**RE:** **Wilder Project, FERC No. 1892-026**  
**Bellows Falls Project, FERC No. 1855-045**  
**Vernon Hydroelectirc, Project No. 1904-073**

**ILP Study 2 and Study 3 — Riverbank Transect and Riverbank  
Erosion Studies — Study Report released August 1, 2016**

**CONTENTS: Landowner's comments, Study 2/3, (Comment period ends  
September 29, 2016).**

TransCanada study, page 70  
"Cycle of Erosion" August 2016

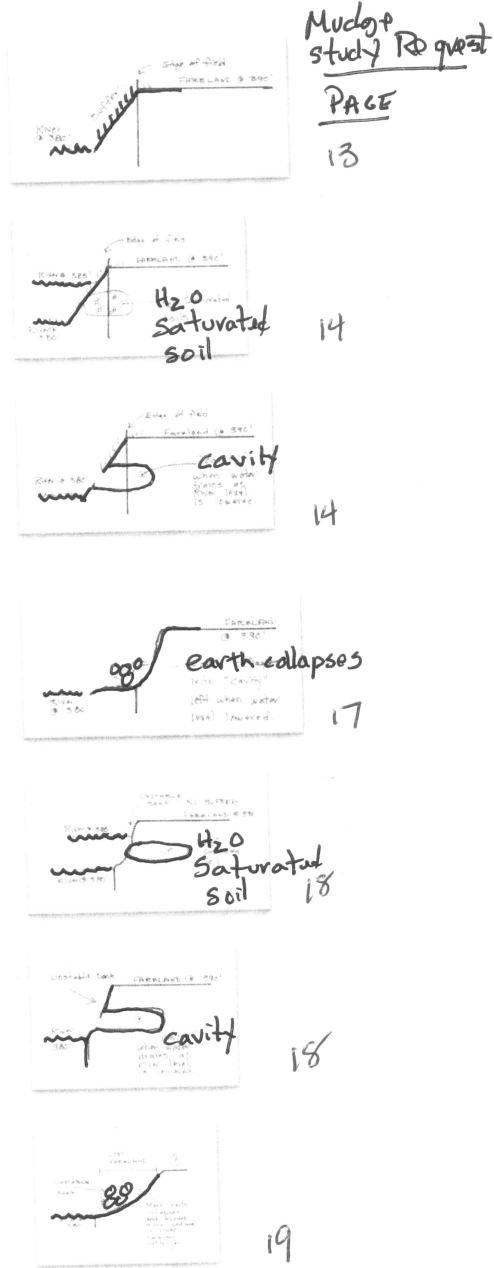
In Study 2/3, Figure 5.6.2-1, page 70, is TransCanada's diagram of the "Cycle of Erosion." The sketches are very interesting, but those sketches should be compared to the sketches that I included in my original Study Request of February 25, 2013. Carefully examine pages 13, 14, 17, 18 & 19 of my Study Request.

They are basically the same diagrams, but with a very important thing missing from the TransCanada drawings. TransCanada draws a "Stable" bank and I have a sketch with a "Buffer." TransCanada has a "Notch Overhang" and I have a "Cavity." TransCanada has a "Slide Mass" and a "Flow" that I call "Earth collapses." TransCanada writes, "Secondary Notch Overhang" and on page 18 & 19 of my Study Request I again show the "Cavity" and more "Unstable Bank."

What is the difference between these two sets of sketches? It is very simple: *TransCanada does NOT illustrate the river and the fluctuations in the water level. My sketches DO illustrate the fluctuations in the water level!* Below I have reproduced both the TransCanada sketches from Study 2/3, left, and the sketches in my Study Request, right. You can not address the issue of erosion on the Connecticut River without taking into consideration the operations of the dams.

*Beach = River-level never changed*

*wavy lines = changing river level*

If you exclude the river from your sketches, as it is excluded in the TransCanada sketches, then you must wonder what causes the erosion. In all of its sketches TransCanada leaves the water at the “beach.” *Visit the river and you will see that the water is not at “the beach” at all times.* TransCanada raises and lowers the water in order to generate electricity for the spot market and this sudden raising and lowering of the water has an adverse affect on the saturated and highly permeable soils that are the riverbank. To have excluded the raising and lowering of the river from the “cycle of erosion” diagrams so discredits that discussion as to make it worth less than the time of day.
